#### **Town of Leicester PLANNING BOARD**

#### PLANNING BOARD AGENDA Tuesday August 31, 2021 @ 7:00PM

Re: Definitive Subdivision Plan Parker Street (North)

Leicester Planning Board Parker Street (North), Definitive Subdivision Plan July 6, 2021 Page 2 of 4

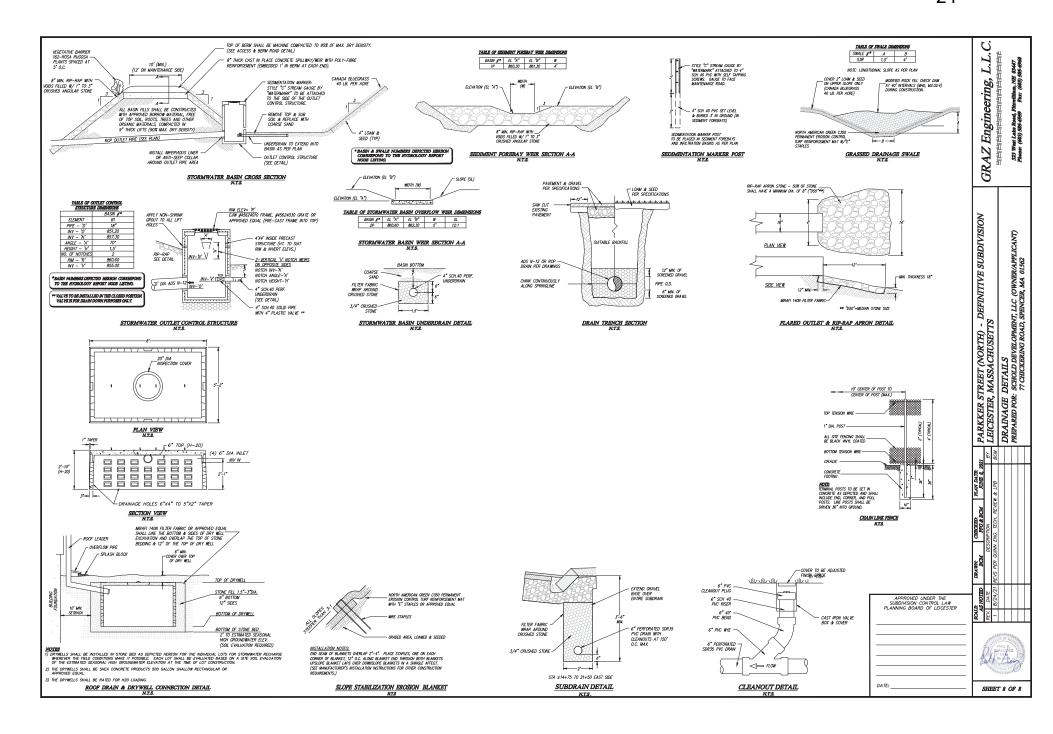
7. The Stormwater Basin Cross Section, Sheet 8 of 8, calls for planting a row of thorny rose bushes ("Rosa Rugosa") along the outside crest of the stormwater basin berm (Infiltration Basin #2P), as a deterrent to entry. The roses cannot be planted on either the gravel access road, nor the Emergency Spillway. Some other means of restricting access over those areas must be developed.\

The plans have been revised to depicted two (2) means of entry deterrent to the stormwater basin (B1). Chain link fencing will be used at the entry point with the proposed roadway as well as across the top of the basin spillway weir. The remainder of the perimeter shall have the "Rosa Rugosa" plantings installed as depicted on the plans accordingly.
